January 24, 1985  
PY-CEI/NRR-0173L

Perry Nuclear Power Plant  
Docket Nos. 50-440; 50-441  
IDI Inspection 84-29 Response

TABLE OF CONTENTS

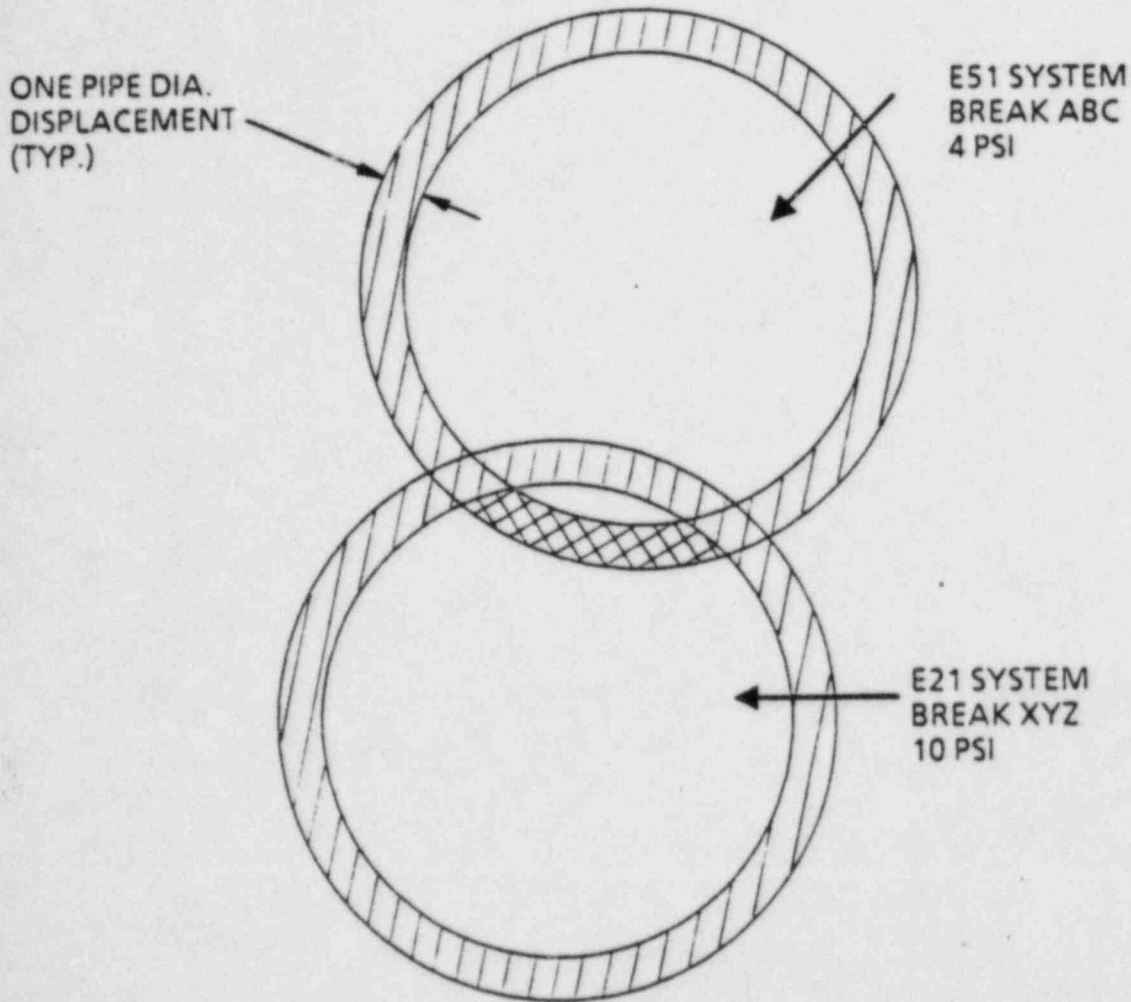
This item states that the method used in the pipe break and jet displacement study (Jet Study) to determine increases in jet impingement envelopes due to pipe displacements potentially excluded some targets which should have been included.

We concur with the IDI Report that the potential exists for missed targets in the discontinued band (See Figure 1) due to the methodology used. The impact, however, of not investigating for additional targets in the discontinued band is considered insignificant based upon the following:

1. Approximately 50% of the jet impingement envelopes do not have any overlap, or the overlap is from breaks within the same piping system, so the higher pressure jet will be the limiting design case.
2. For the remainder of the jet envelopes, the actual physical area of the discontinued band in relation to the full jet envelope is typically very small. Figure 1 is representative of this relationship. As a result, there is a low probability of a safety-related component being located totally within this excluded zone. Thus, structures, systems, and components are still appropriately protected against any discharging fluid from a ruptured pipe, as required by 10 CFR, Part 50, Appendix A.
